SSD T/A CREWSAVER SERVICING AND MAINTENANCE BULLETIN No. 49

SUBJECT: Change of retaining clip on Halkey Roberts Manual Head

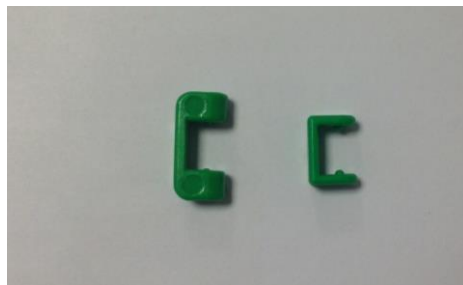
There has been a change in the Retaining Clip fitted to the Halkey Roberts Manual Firing Head – Sales Part No. 10210. The new type clip is smaller than the existing clip, as shown in the illustration below.

Supplies of the existing clip held by Service Stations can still be used but when future orders are placed for Part No. 10210 the new type clip will be supplied.
